## ORIGINATION FORM

Proposed Revisions to a Standard Plans Index  
(Please provide all information — Incomplete forms will be returned)

Index Number: 700-120

Index Title: Enhanced Highway Signing Assemblies

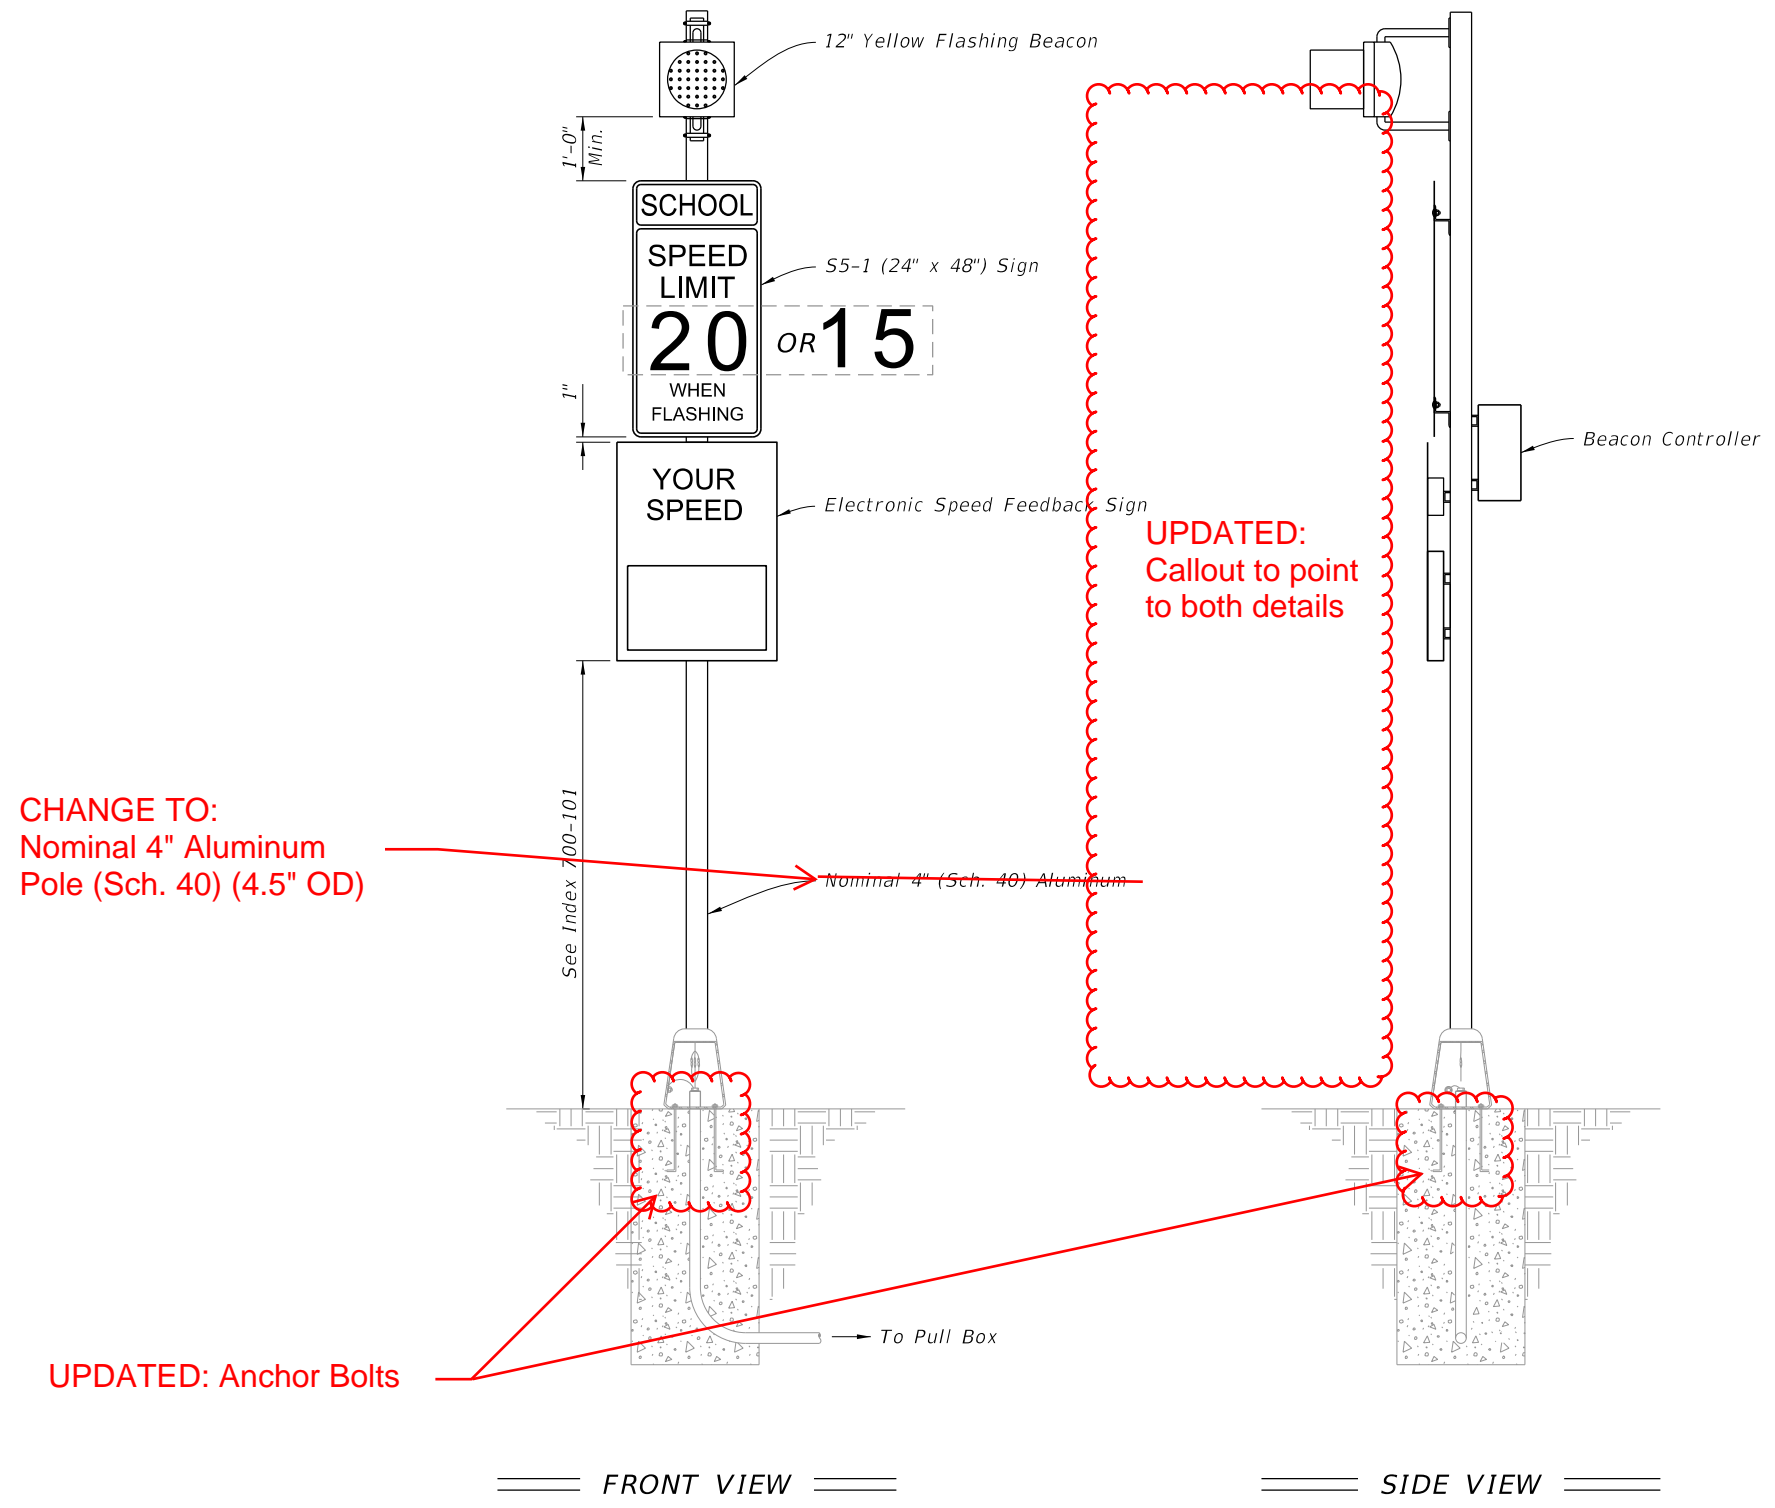
**ADDED NOTE:**  
Foundation reinforcement not shown.

**ROADSIDE SIGN ASSEMBLY-4**

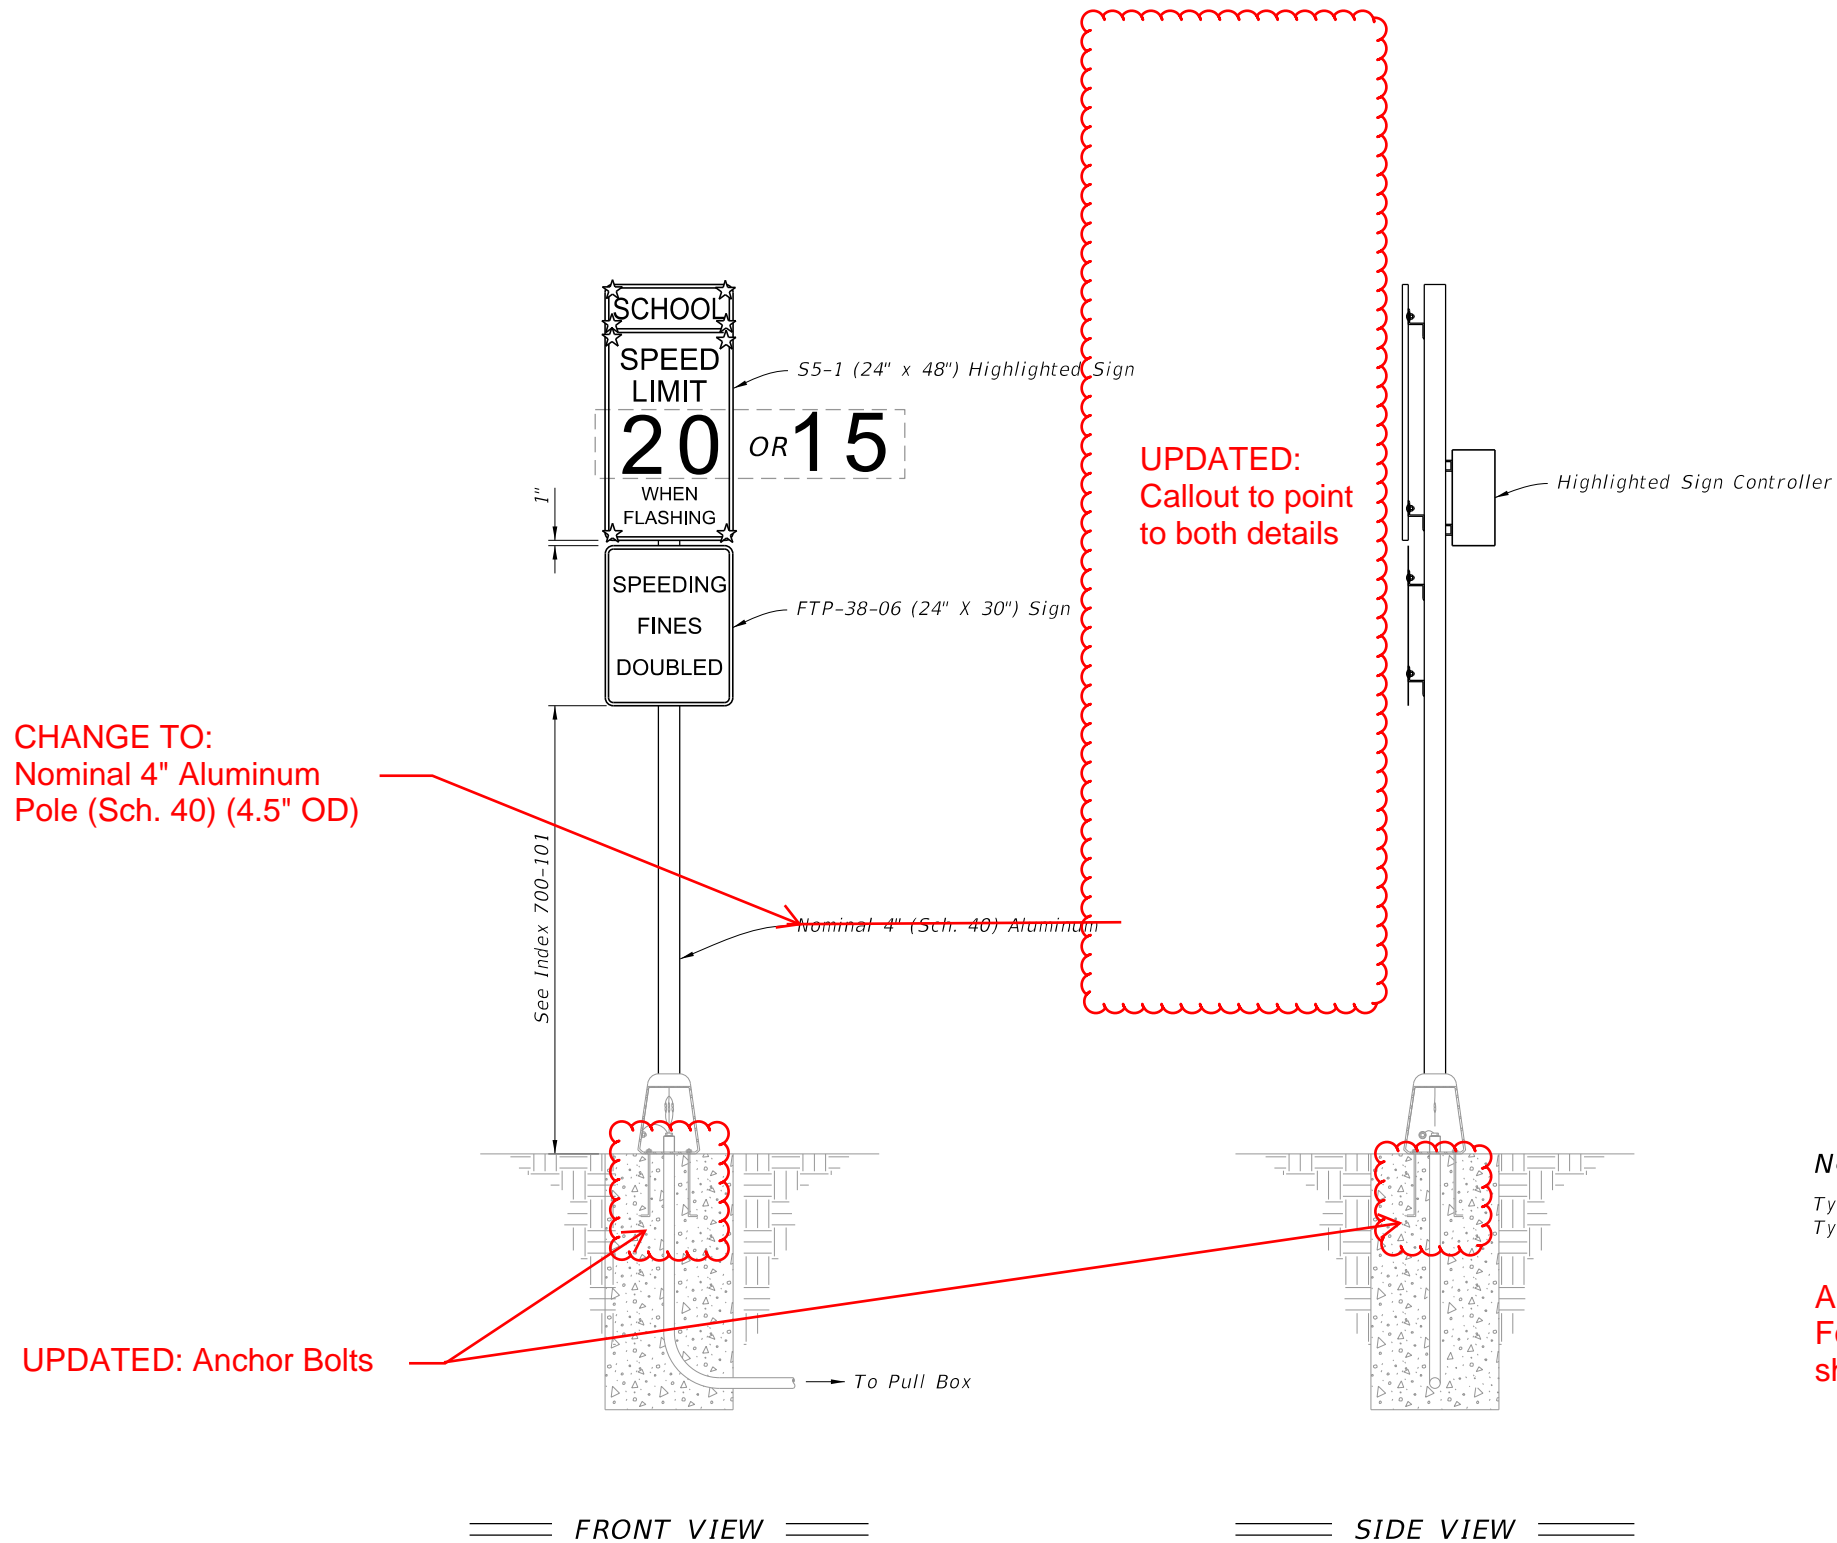
**ADDED NOTE:**

Foundation reinforcement not shown.

**ROADSIDE SIGN ASSEMBLY-5**

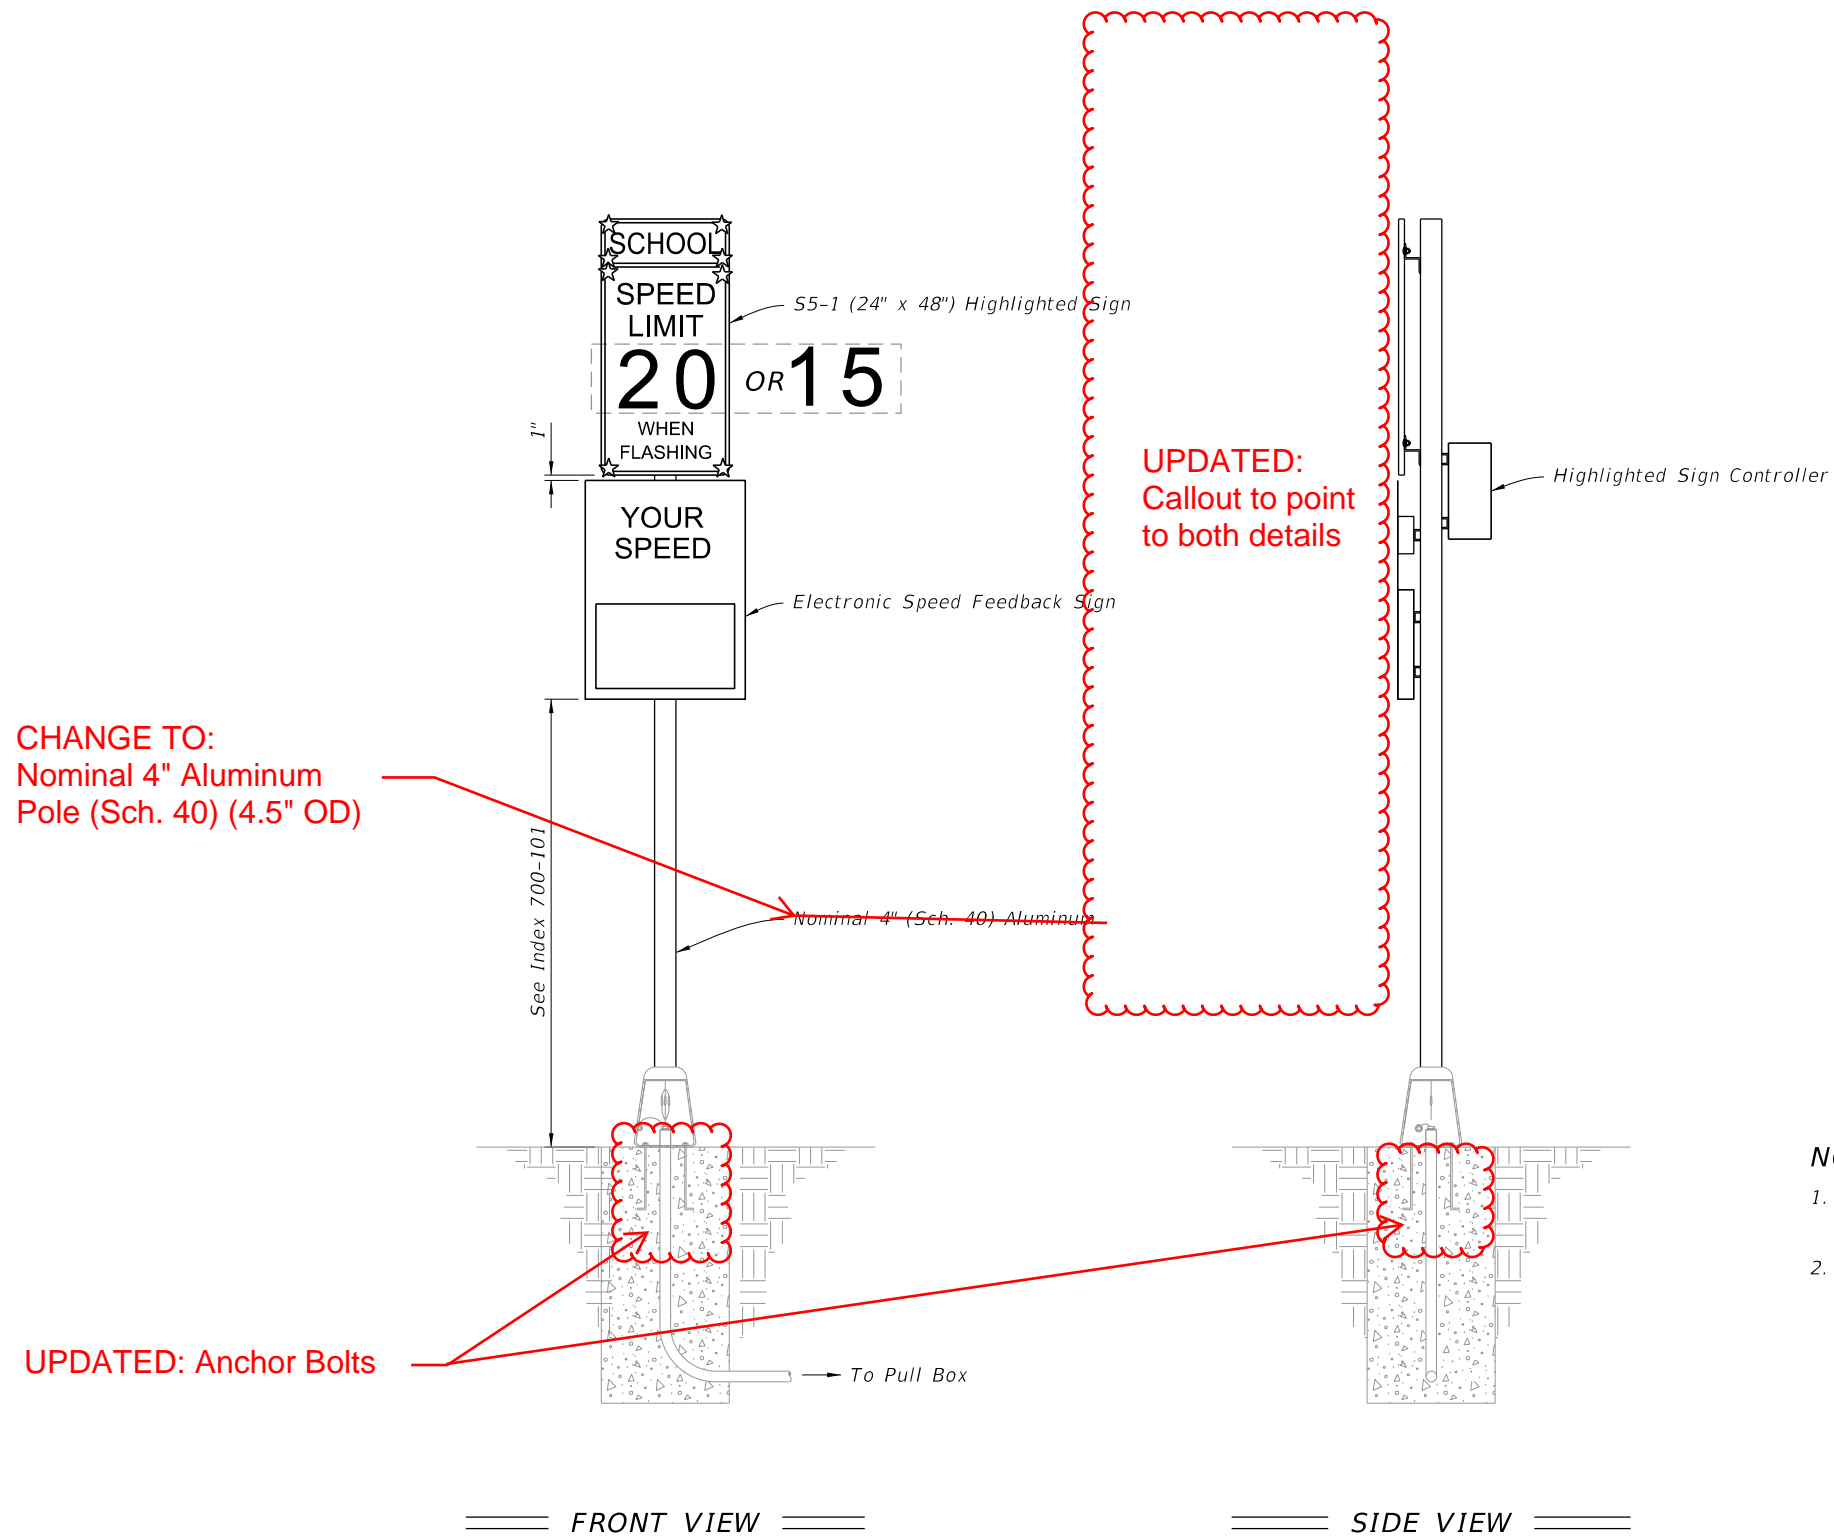
**ADDED NOTE:**  
Foundation reinforcement not shown.

**ROADSIDE SIGN ASSEMBLY-6**

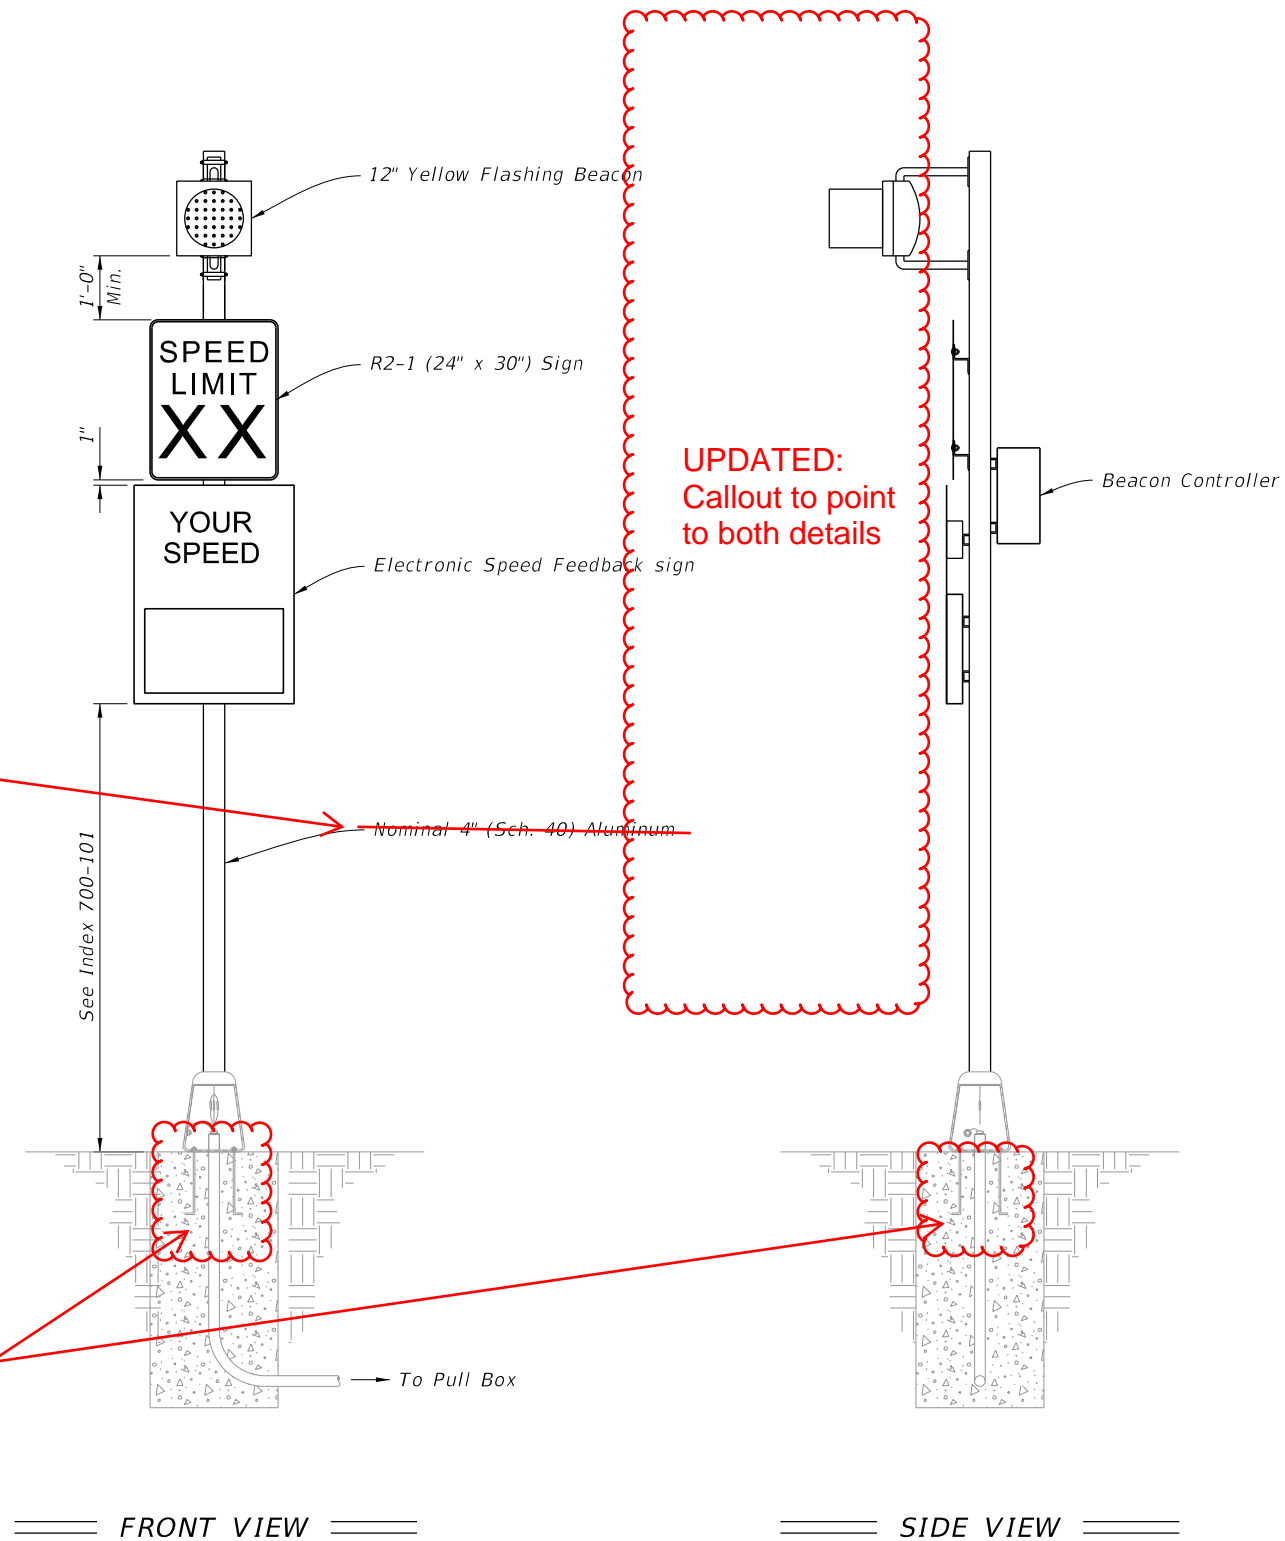
CHANGE TO:  
Nominal 4" Aluminum  
Pole (Sch. 40) (4.5" OD)

UPDATED: Anchor Bolts

UPDATED:  
Callout to point  
to both details

**ADDED NOTE:**

Foundation reinforcement not shown.
